ADDENDUM A

Staff Report Z-42-23-7

*REVISED November 1, 2023

The purpose of this addendum is to revise the language for Stipulation Nos. 3, 15, and 17 to reflect the updated site plan submittal date, to ensure when the EV spaces are installed, and to clarify the traffic control device type, location and funding.

dwg name: PRELIMINARY
OVERALL SITE PLAN
dwg no: SD1.11
date: 10-31-2023
job no: 2021.18
log no:

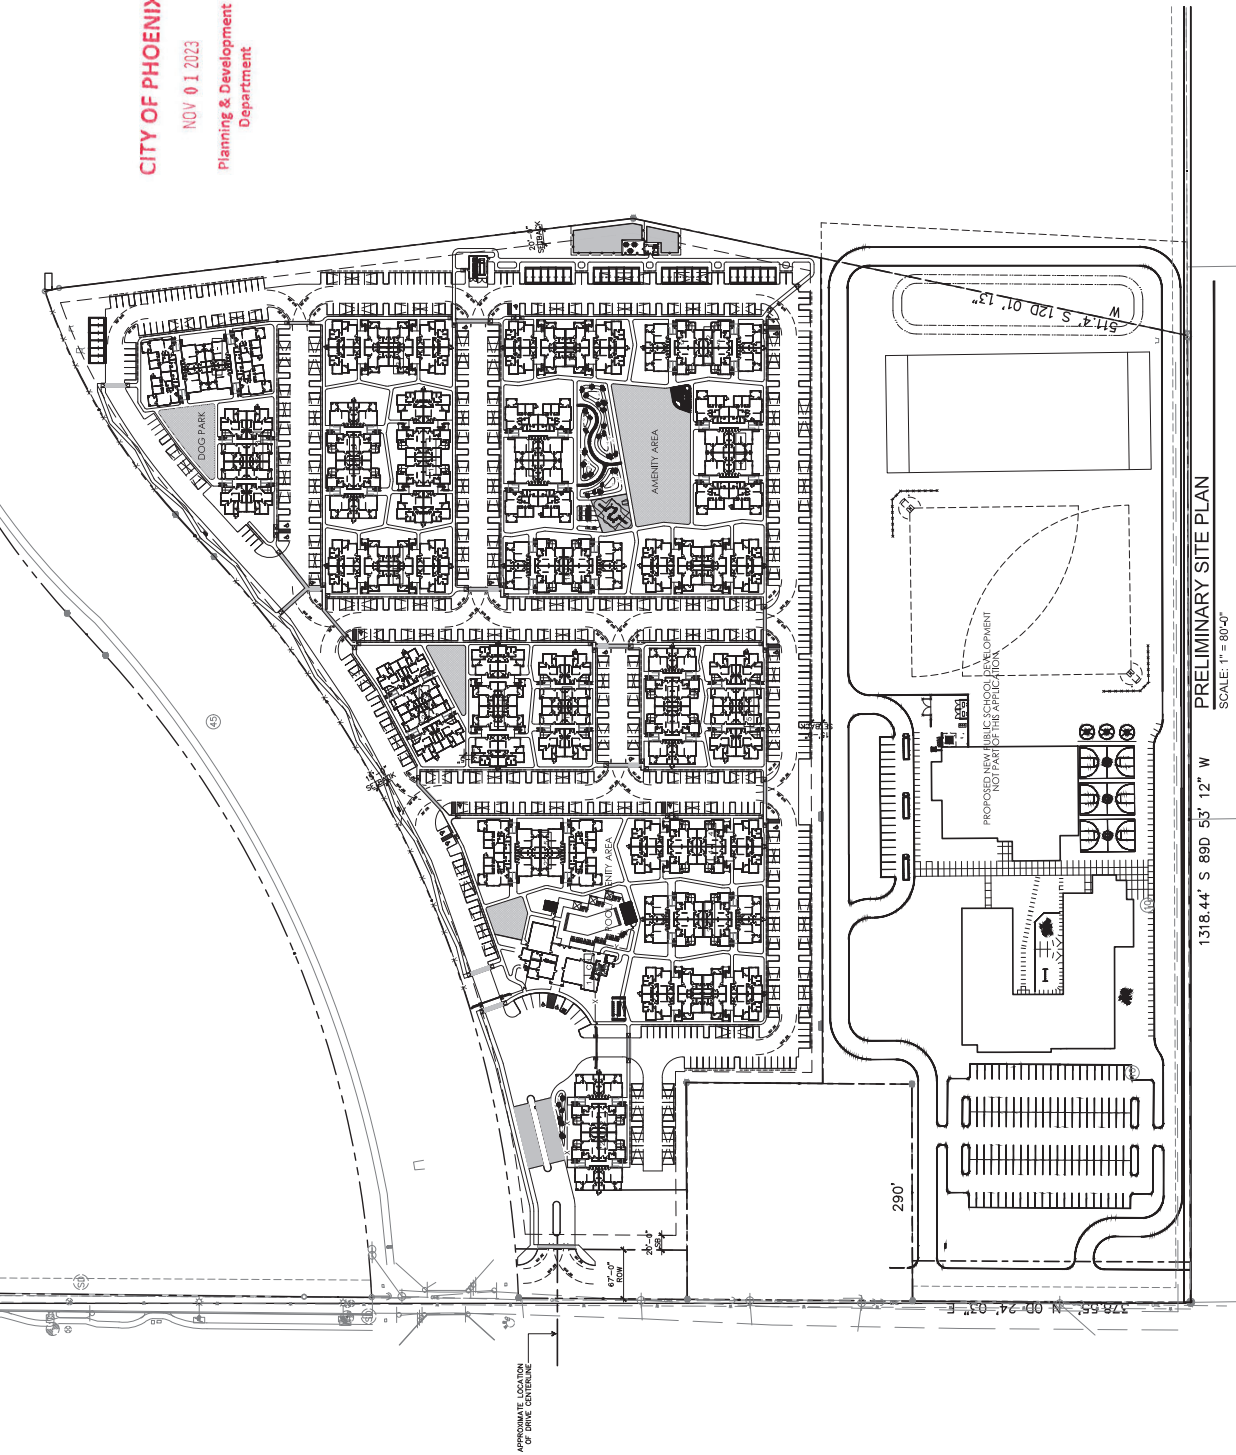
On October 16, 2023 the Laveen Village Planning Committee (VPC) heard this request and recommended approval, per the staff recommendation with modifications and additional stipulations. Stipulation No. 3 was added to require general conformance to the revised site plan to be submitted by the applicant after the *meeting. The applicant has since submitted a revised site plan on November 1, 2023 that meets the required building setbacks when adjacent to the Loop 202 Freeway.

- *3. THE MULTIFAMILY DEVELOPMENT SHALL BE IN GENERAL CONFORMANCE ~~TO THE FUTURE SITE PLAN SUBMITTED BY THE APPLICANT~~ WITH THE SITE PLAN DATE STAMPED NOVEMBER 1, 2023, AS MODIFIED BY THE FOLLOWING STIPULATIONS AND APPROVED BY THE PLANNING AND DEVELOPMENT DEPARTMENT.

*Revised Conceptual Site Plan date stamped November 1, 2023
